Re: VARIANCE REQUEST  
SWOPE PROPERTY  
1910 CEDAR ROAD  
PASADENA, MD 21122

**RE: VARIANCE REQUEST  
SWOPE PROPERTY  
1910 CEDAR ROAD  
PASADENA, MD 21122  
VARIANCE APPLICATION**

### CONFIRMATION OF PRE-FILE MEETING

**PROPOSED CONDITIONS PLAN**  
SCALE: 1" = 20'

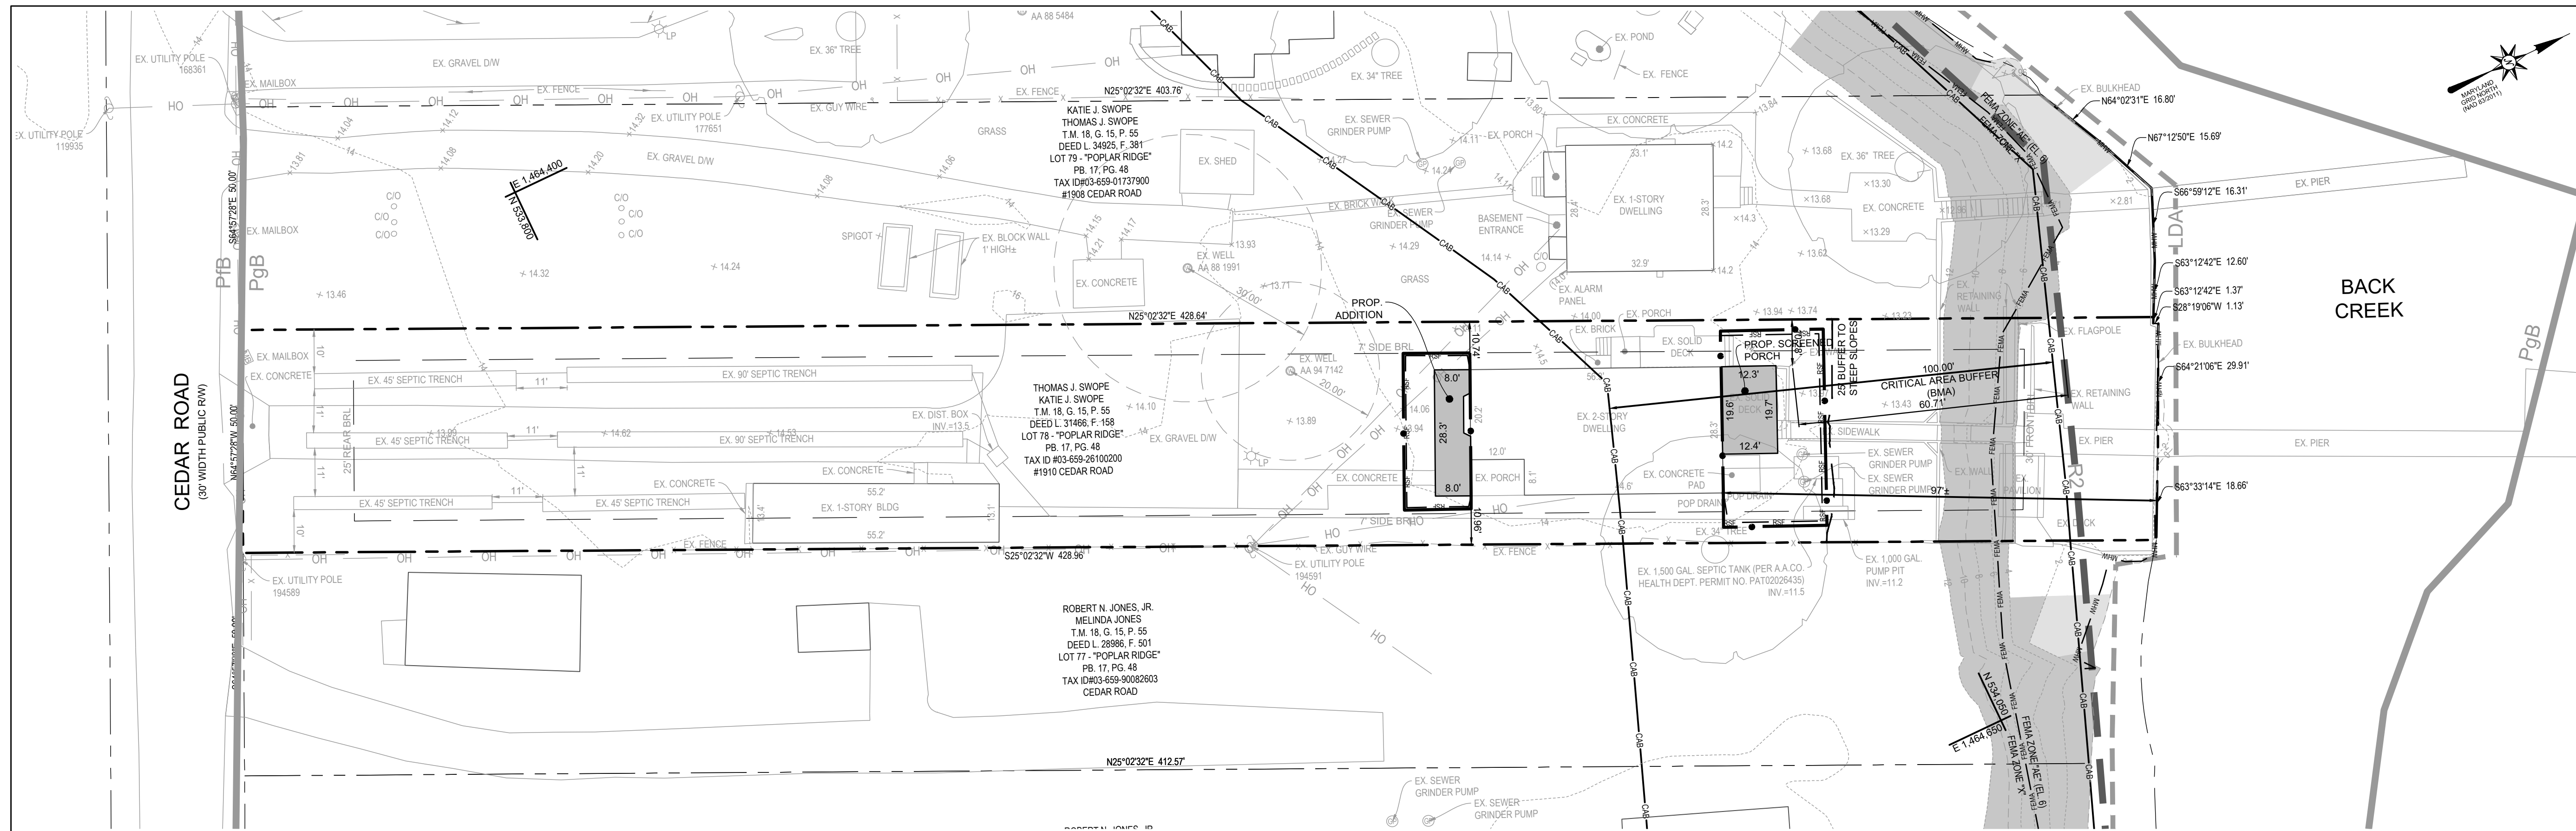
The waterward portion of the first floor of the existing home is built as a sunroom and provides a protected area from which to enjoy the view and the outdoors. Additional clarification must be provided in terms of minimization and need to justify this application. Please clarify if the porch addition is screened and whether either of the additions contain a second story. Provided the applicant can justify the enclosure, it should be limited to the size of the current deck and not expand even further into the buffer.

A generally in line variance is also required.

Applicant needs to provide further info as per above comments and demonstrate 16 by 20 foot porch is minimum necessary.

In response to comments generated by the pre file submittal, the screen porch addition has been minimized. The size of the porch is now noted as the same footprint as the existing deck.
